NAVAJO-GALLUP WATER SUPPLY PROJECT
NEW MEXICO

SAN JUAN LATERAL - BLOCK 2 - 3

REACH 3 - LINE PIPE

1695-D-62472

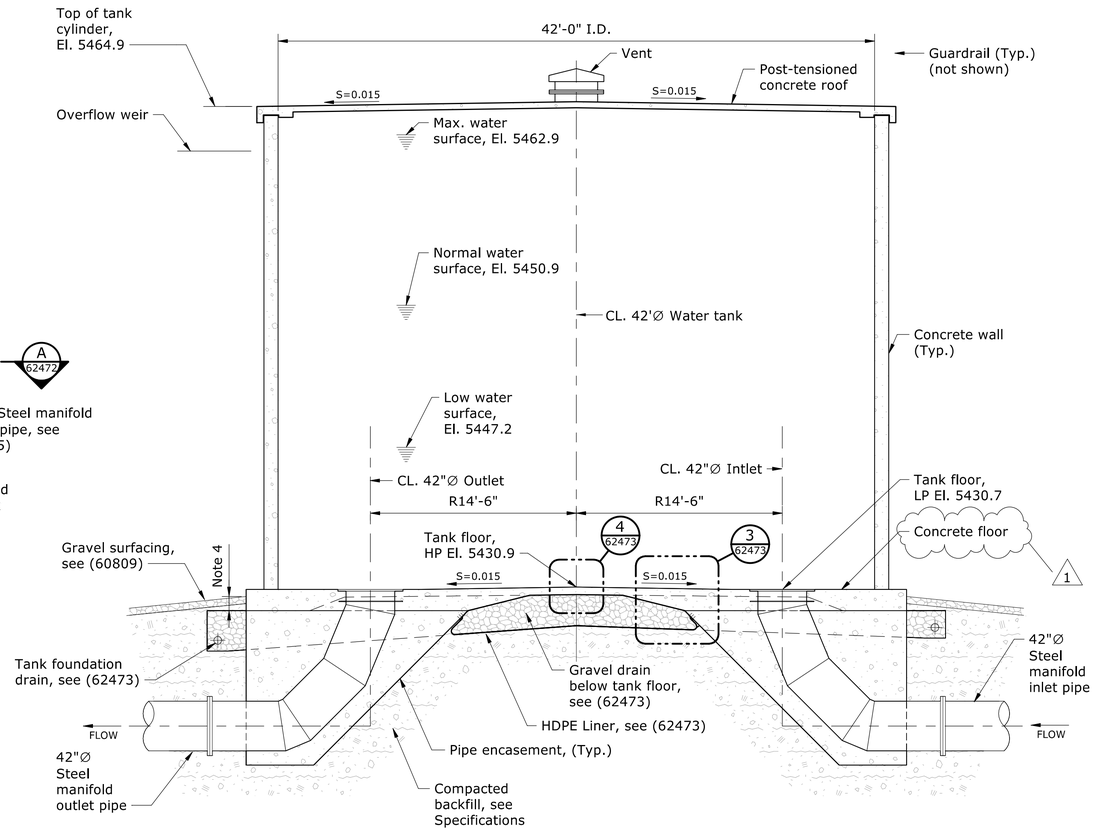
REV NO	STA. D	2026-06-04 Lisa Orgren	Added geotechnical data and updates to callouts.
1

1695-D-62475
SHEET 1

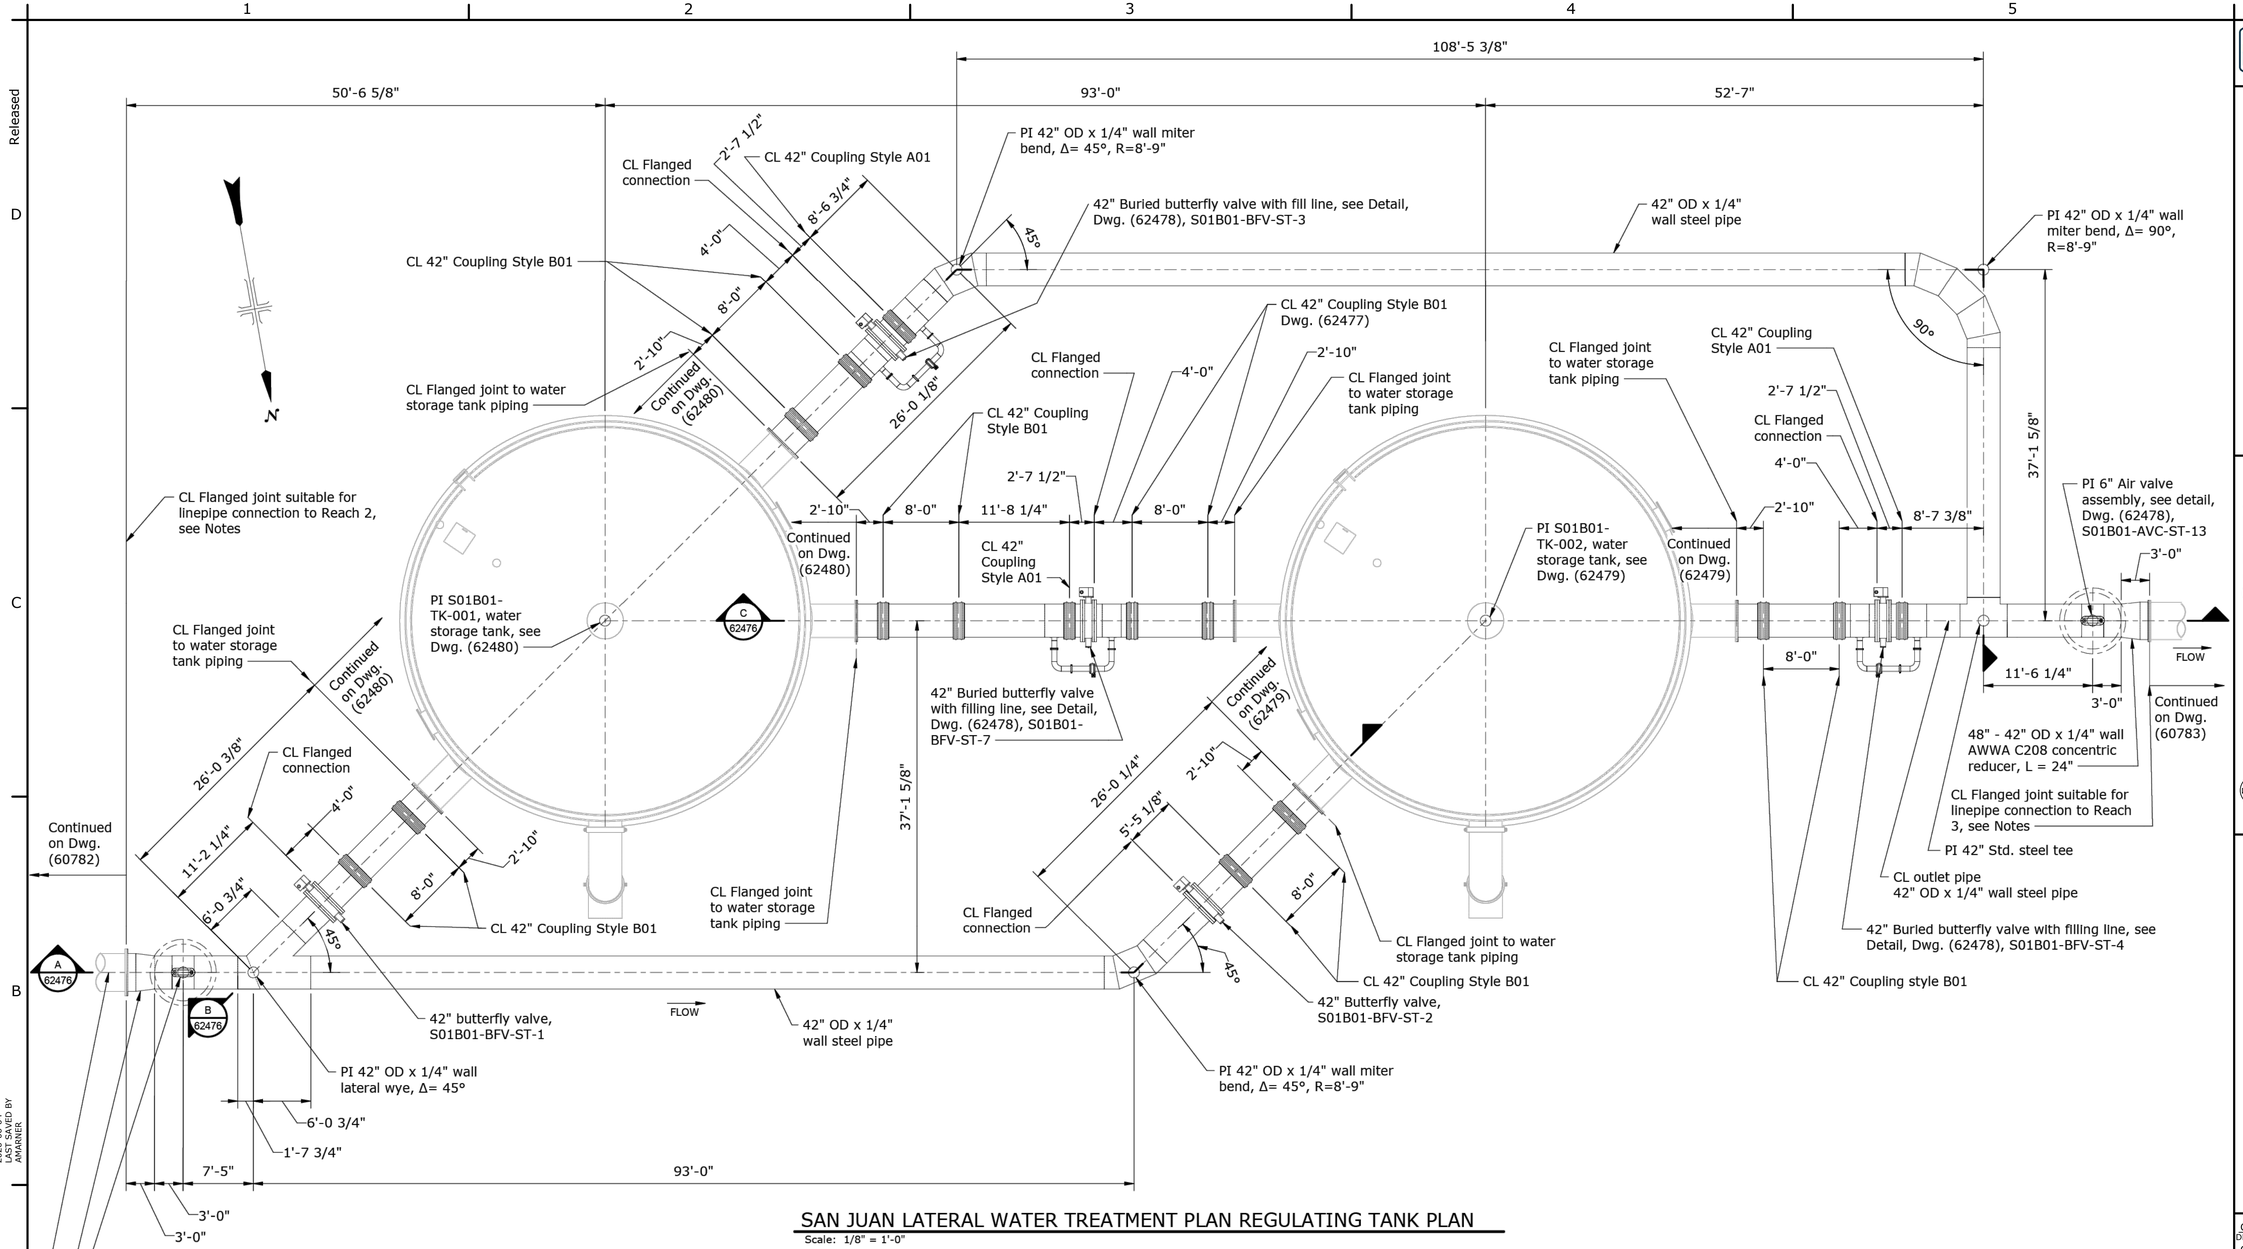
REV NO | DATE | DESCRIPTION
1 | 2026-06-04 | D | Baca, Brantly (Brant) Q P.E. | Remove 6" tank drain, correct weir elevation
